Comment on amt-2022-107 Anonymous Referee #1 comment on "In-situ measurements of NH<sub>3</sub>: instrument performance and applicability" by Marsailidh M. Twigg et al., Atmos. Meas. Tech. Discuss., <https://doi.org/10.5194/amt-2022-107-RC1>, 2022

**Summary:** Ammonia (NH<sub>3</sub>) is not regularly monitored in networks. It is also an unregulated pollutant in many countries. Identifying a standard among the available technology for routine gas-phase ammonia monitoring is vital to our understanding of this pollutant and how future regulation policy can be shaped. This paper describes a comprehensive intercomparison of 13 instruments for sampling gas-phase NH<sub>3</sub>. The study is done in-situ at an agricultural field site in Scotland. The instruments represent a variety of currently available technologies for measuring gas-phase NH<sub>3</sub>. The authors perform a comprehensive analysis of the available data and show that variability in the ensemble is within 20%. This alone is an interesting finding from an intercomparison of 13 independent NH<sub>3</sub> instruments of varying techniques and time responses. While there are still nuances of instrument setup, maintenance,

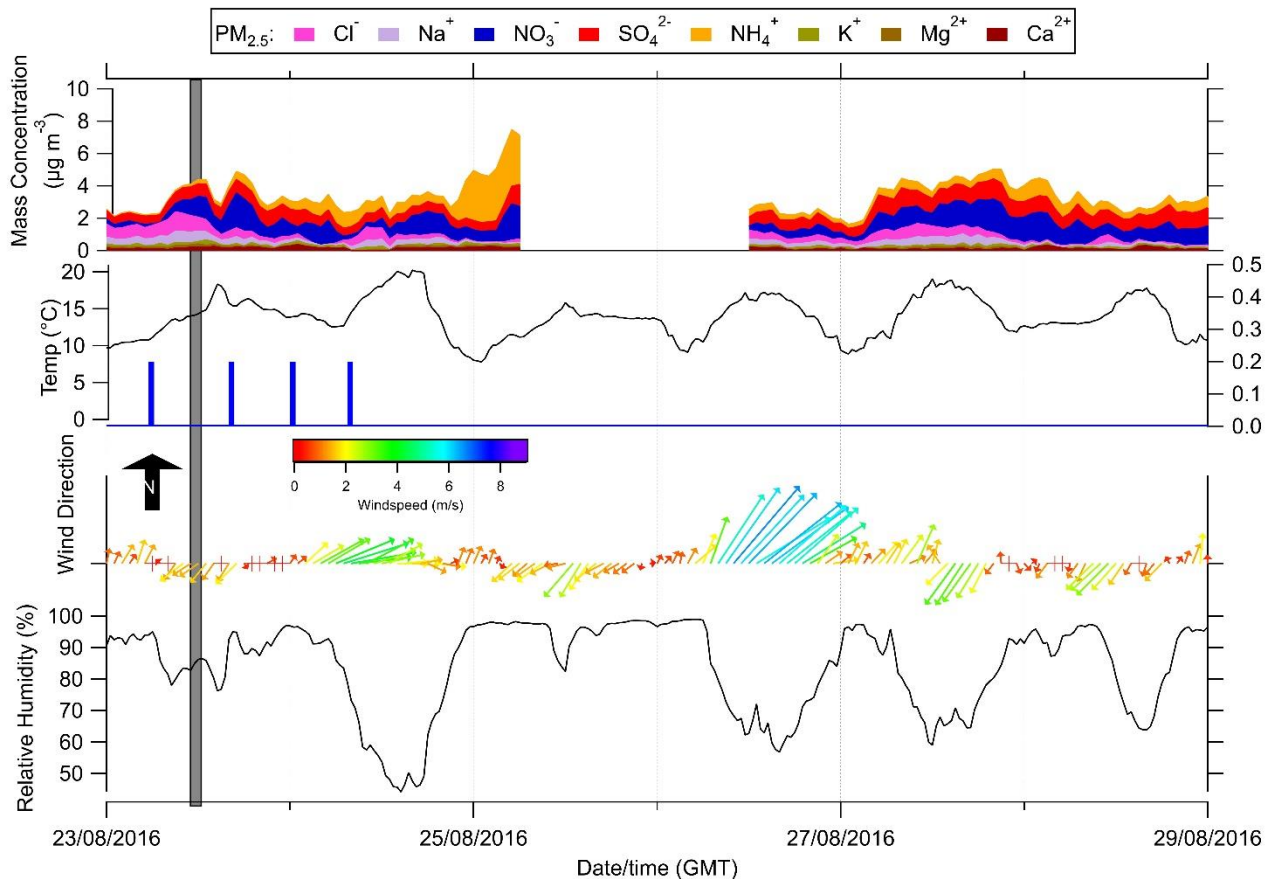
Instruments were in the field from 22 Aug to 2 Sept. Is there a reason that only 23 Aug and 29 Aug is used for the intercomparison study and not the full period? There are inconsistencies in the dates in several places throughout. For example, Figures 8 and 9 and Table 4 suggests a start date of 22 Aug instead of 23 Aug. There are also inconsistencies in the dates in some of the figure captions and table headers in the SI.

Figure 2. Please add something (e.g., shaded bar, horizontal arrow, red dashed lines) to indicate the period of data used for the instrument intercomparison (which I think is 23 Aug to 29 Aug). Is there a reason that the remaining data in the timeseries up to 02 September was not included in the intercomparison?

In addition Section 3.1 was updated to reduce the period of meteorology discussed to cover only the period of the 23<sup>rd</sup> to 29<sup>th</sup> August, as well as reducing the period show in Figure 2 (see below). The text describing period now states:

To avoid confusion the period presented has been reduced to the 23<sup>rd</sup> August to the 29<sup>th</sup> August which only encompasses the period that data was used for comparison study.

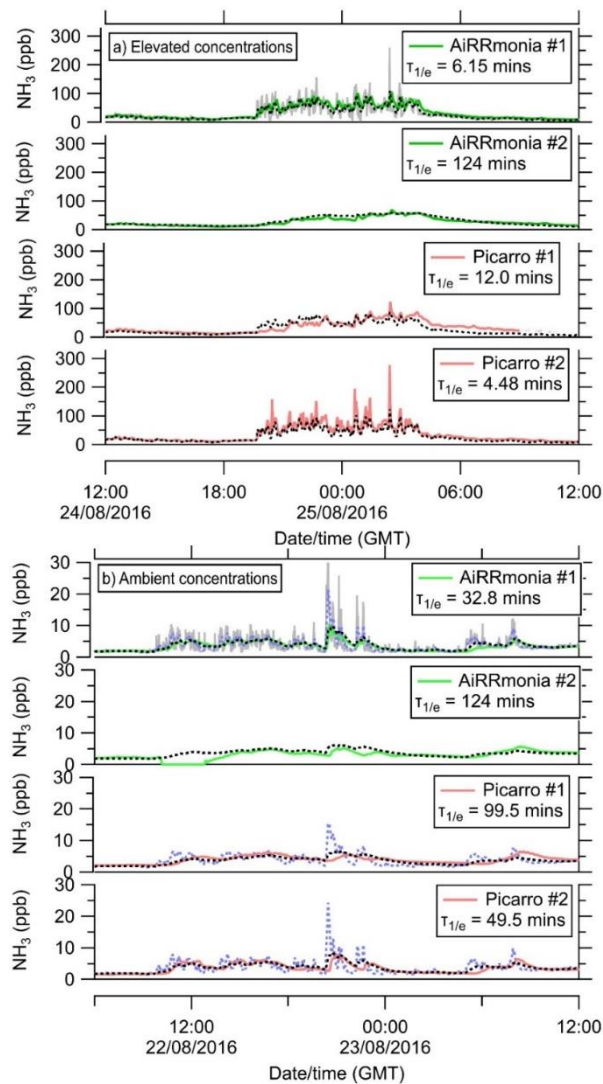
P18, L13: Is the response time truly different under ambient conditions? Without the same level of fine structure in Figure 7b as in Figure 7a, it is difficult to accept the levels of smoothing applied to the DOAS under ambient conditions to match the profiles of the AiRRmonia and Picarro instruments. Can you include another trace in 7b to show the DOAS signal with the same level of smoothing as in 7a? This would help highlight whether additional smoothing of the DOAS is indeed needed to match the features of the AiRRmonia and Picarro instruments under ambient conditions.

We have now updated Figure 7 to include an additional line in Figure 7b which is the smoothing applied in 7a) to demonstrate to the reader the loss in structure and reduced concentrations detected at ambient concentrations.

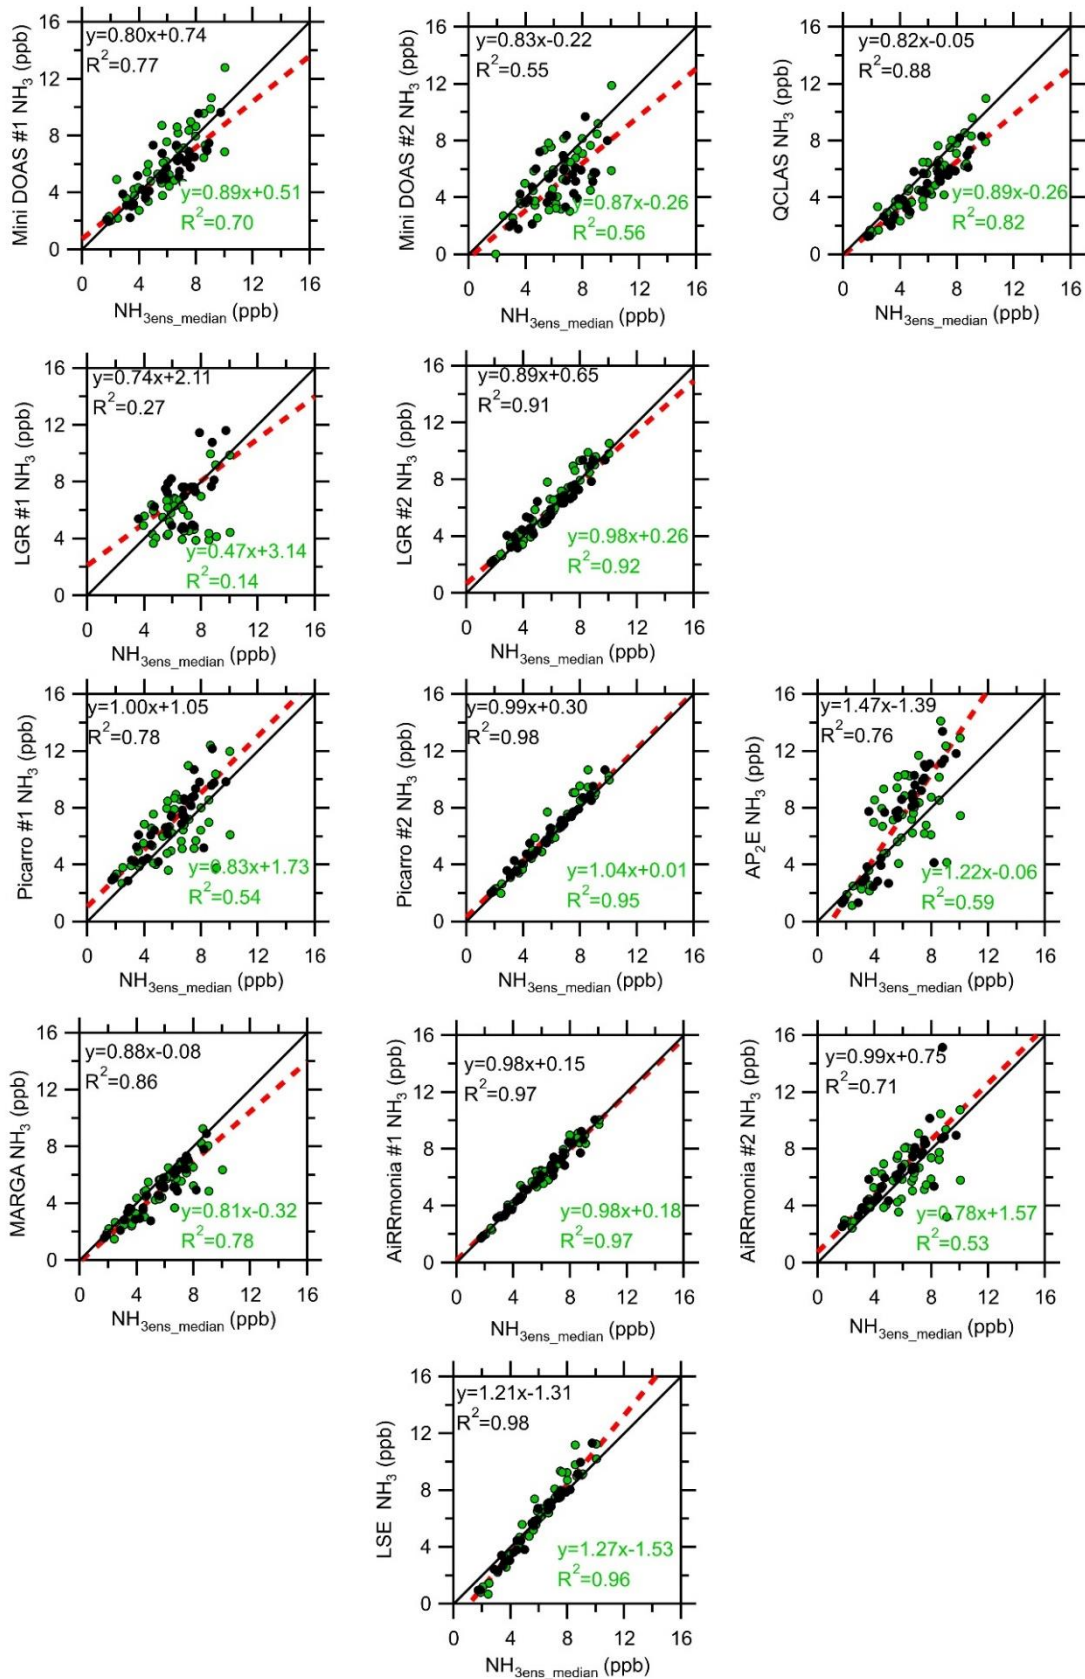
Figure 8. The met filter looks like it could have induced some bias in some of the fits. The met filter was applied to eliminate low wind speed and unstable conditions that could have led to inhomogeneity between the inlets at the field site. But didn't the ALPHA samplers indicate that there was homogeneity during the study period? What do the fits look like without the met filter? At a minimum, you should comment in the text about any differences in fits with and without the met filter applied.

The data presented in Figure 8 includes all data below 10 ppb with the open circles being the data removed after the met filter was applied. The green legend provides information of the comparison for all data, whereas the black legend is the filtered data as outlined in the caption. So the bias is reflected in the difference of the two fits. It is likely that stable conditions that occurred would lead to inhomogeneity of the concentration field and is where the highest concentrations are observed, which the LTMHTR instruments reported. As we have already stated in the text there was an observed improvement in the precision by applying a met filter ( $R^2$ ) however we acknowledge the slope and intercept did alter through the application of the filter on some instruments. For example, for the LGR #2 the slope reduced and the intercept increased due met filter being applied. We have now revised the text to include the following in the manuscript:

*"It is noted, that the slopes and intercepts changed in applying a meteorological filter. In general instruments with faster response found their slopes reduced, whereas the reverse was observed for the instruments with the slower time response. With the exception of the AP<sub>2</sub>E, slopes after filtering were closer to unity and with the additional exception of Picarro #2 the intercepts decreased. For the remainder of this discussion however we will only discuss the filtered data."*

In addition we have modified Figure 8 by colouring the open circles green, in order that it easier for the reader to relate to the green legend:
